Report to Planning and Environment Committee

Subject: Auburn Homes Inc. (c/o Steve Stapleton)
1338-1388 Sunningdale Road E
File Number: Z-9740, Ward 5
Public Participation Meeting

Date: September 10, 2024

Figure 3 - Conceptual Site Plan

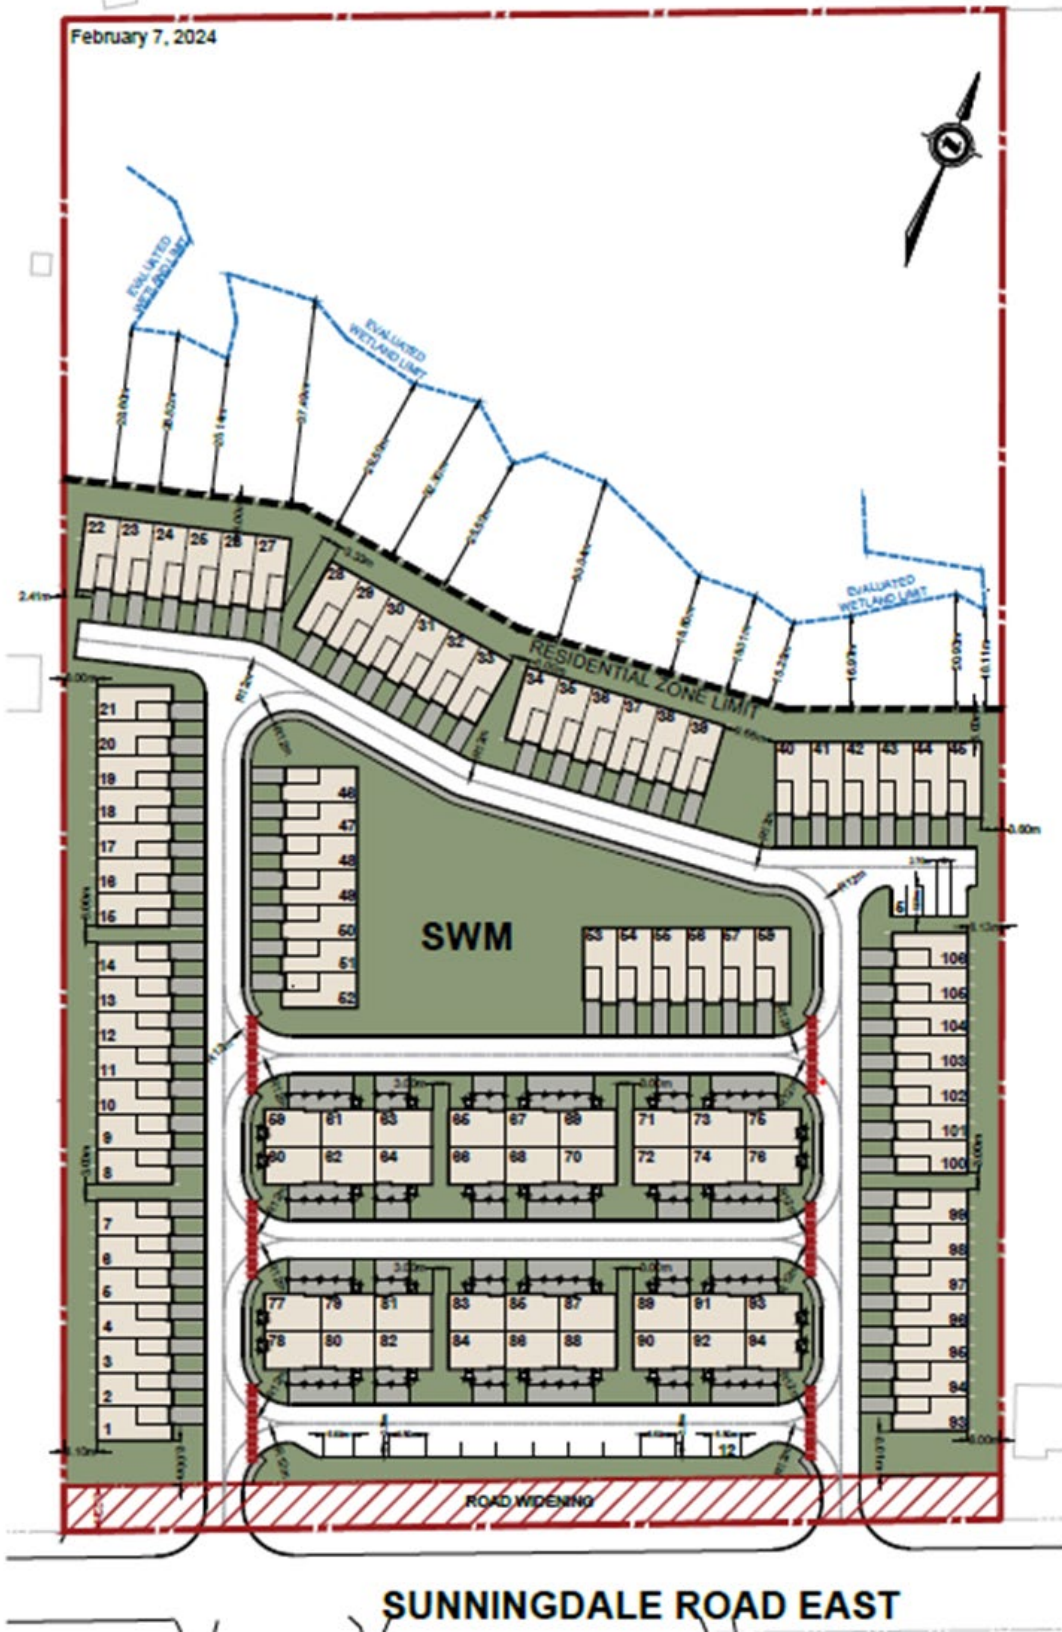
An ecological buffer was proposed to provide physical separation between the wetland and the developed site. It should be noted that the ecological buffer, as initially proposed, was insufficient and did not meet the City's 2021 Environmental Management Guidelines (EMGs).

The applicant submitted a revised application on July 9, 2024 which proposes a 30 metre buffer, with the stormwater management functions in the form of low impact development measures relocated into the buffer. The northern portion of the subject lands continues to be maintained as a wetland area. The proposed ecological buffer provides physical separation between the wetland and the developable site, and meets the requirements of the City's 2021 Environmental Management Guidelines.
